December 20, 2023

**RE: URBAN DESIGN ADDENDUM LETTER / 109, 115 AND 133 BRIDGEPORT ROAD EAST
AND 30 WEBER STREET NORTH/ OPA 40 AND ZBA Z-22-10
OUR FILE 16222B**

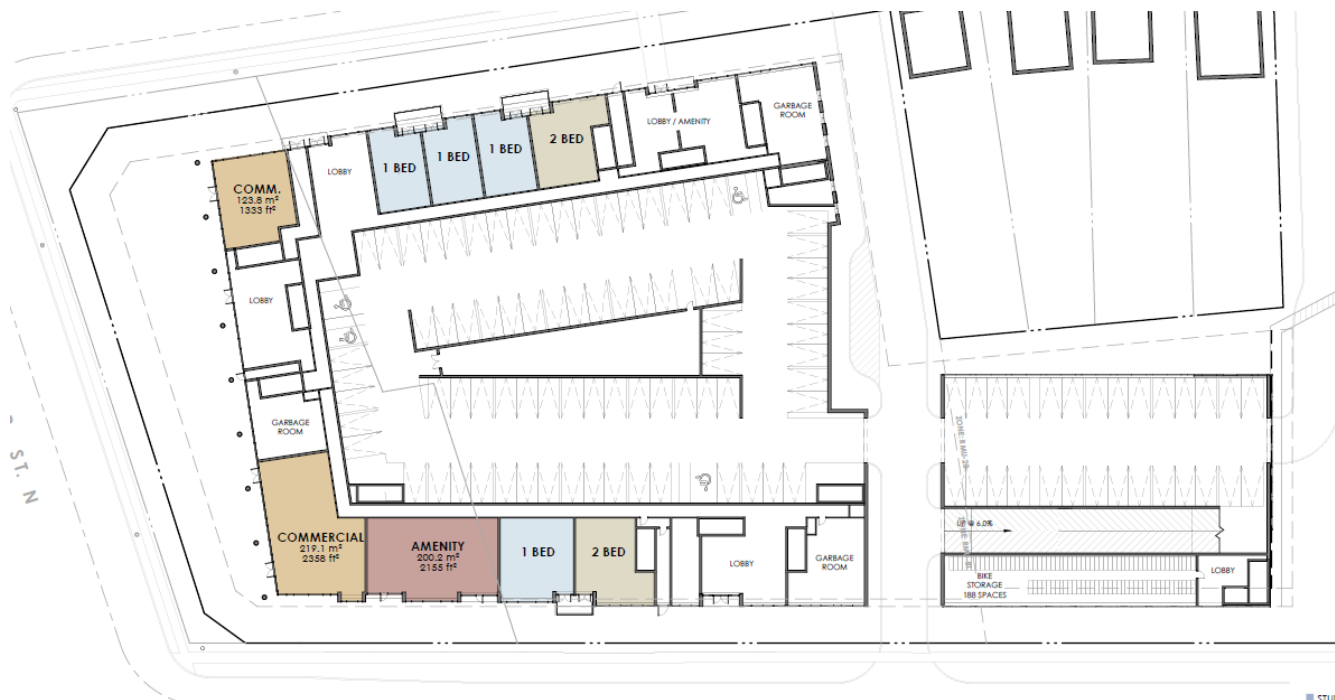
As previously noted, the podium has been shifted further to the west towards Weber Street North to provide additional separation from the lands to the east on Royal Street. The podium now also cantilevers over the westerly driveway access from Bridgeport Road to provide additional massing facing the street. The parking structure component of the podium, east of the driveway access along Royal Street, has been increased to 8 storeys (24.5 metres) in height to provide additional parking in support of the development. The westerly shift of the podium has increased building setbacks along the easterly property line to 16 metres from 196 Royal Street, allowing for additional landscape areas and physical separation.

Ground Floor Plan (Original 2022 Submission)

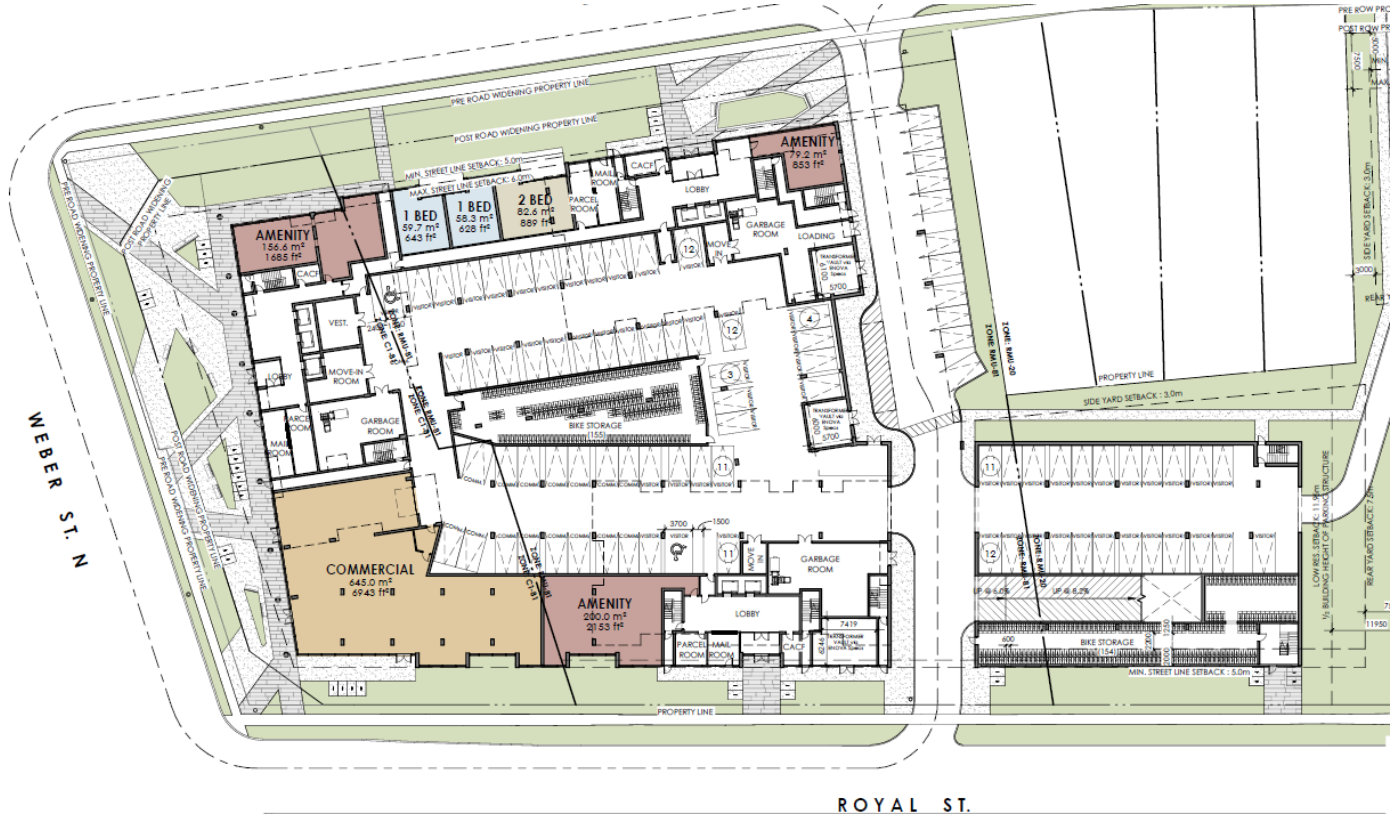
In addition to increasing the amount of ground floor commercial space, other changes have been made to the ground floor layout in order to activate the streetscape through the provision of other active ground floor uses. The below compares the original ground floor design with the revised (December 2023) concept.

In the original submission (pictured above) the ground floor was designed with a number of active spaces including:

- Two commercial units;
- Lobby areas (with lobby areas adjacent to all three street frontages (one for each residential tower);
- An amenity space oriented towards Royal Street; and
- Ground floor residential units along the Royal Street and Bridgeport frontages.

In addition to the above, the ground floor contains parking (screened from abutting streets through the uses listed above). Functional elements such as garbage rooms were also proposed (to be screened through architectural façade design). All of the ground floor uses are connected through a common shared hallway. The parking structure on the eastern portion of the site contained a small lobby area and bicycle parking.
